[Docket No. 2002-SW-22-AD; Amendment 39-12835; AD 2002-08-54]

Airworthiness Directives; Bell Helicopter Textron Canada Model 222, 222B, 222U, and 230 Helicopters

ACTION: Final rule; request for comments.

Figure 1

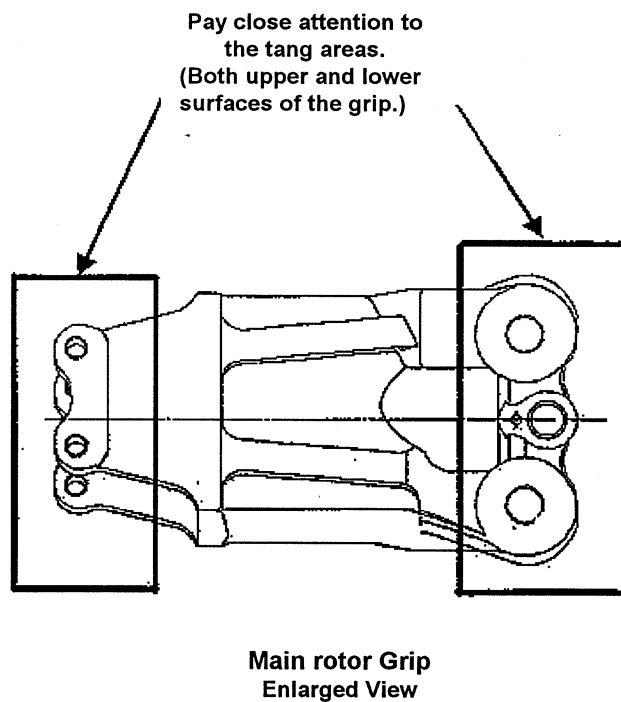
(1) Wipe clean the main rotor grip and pitch horn surfaces to remove grease and dirt in the check area as shown in Figure 1 of this AD:

Figure 2

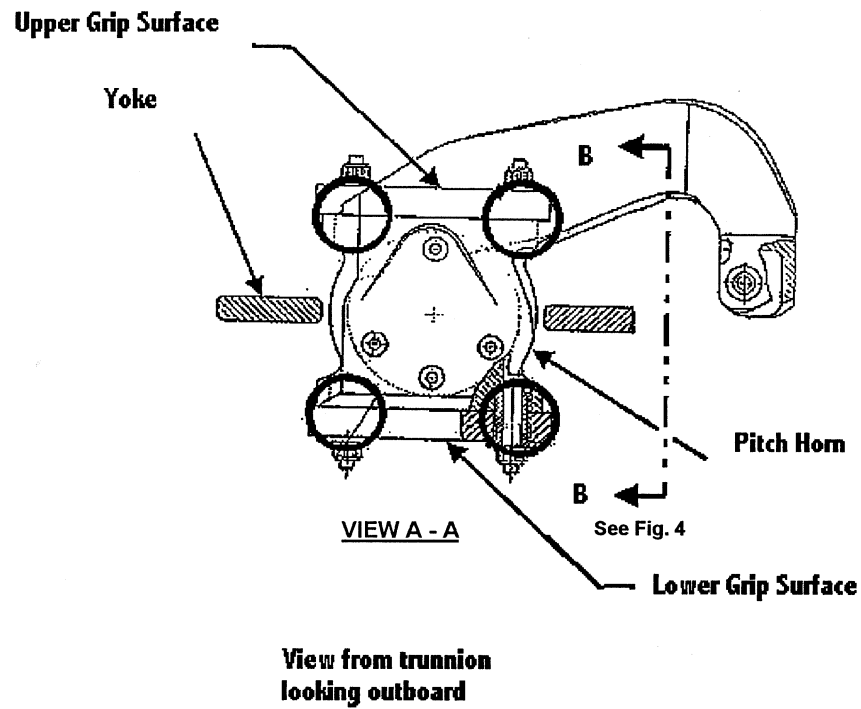
(2) Visually check both main rotor grips for a crack, paying particular attention to the inboard and outboard tangs/portions of the grip, which are in direct contact with the pitch horns and the main rotor blades. Check the area to at least 3 inches beyond the grip/pitch and grip/blade contact areas as shown in Figure 2 of this AD:

Check entire surface of the grip.

Figure 3

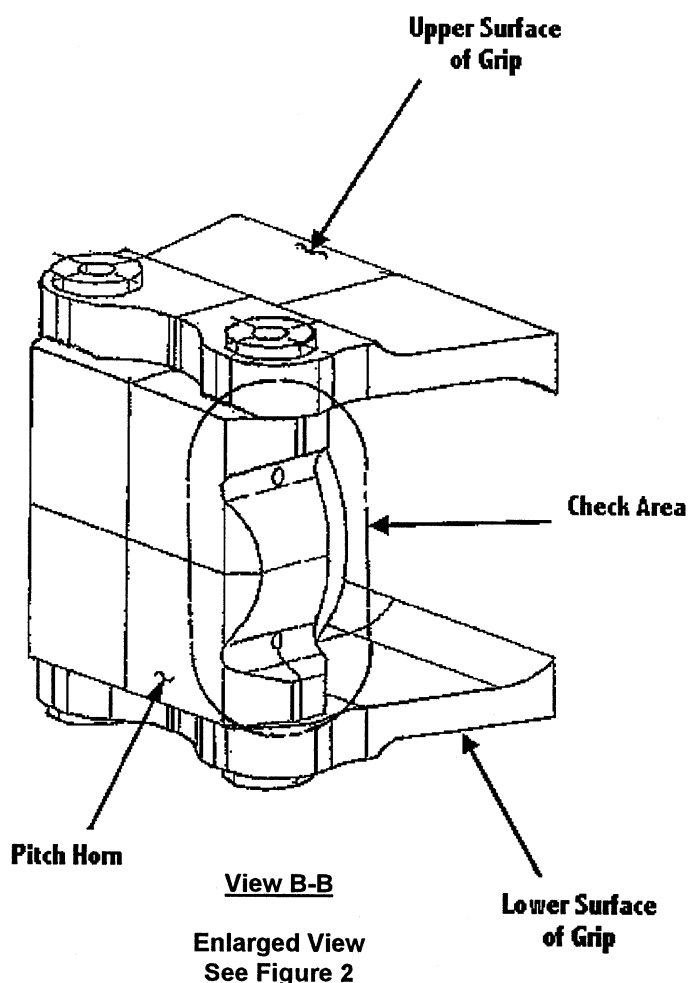
(3) Visually check all visible portions of each pitch horn for a crack. Pay particular attention to the attachment lugs of the pitch horns, which are in direct contact with the inboard tangs of the main rotor grips, as shown in Figure 3 of this AD, and the four large bolt cutouts, as shown in Figure 4 of this AD:

**All visible portions of the pitch horn must be checked.
Pay particular attention to the circled areas shown above and View B-B, Fig. 4.**
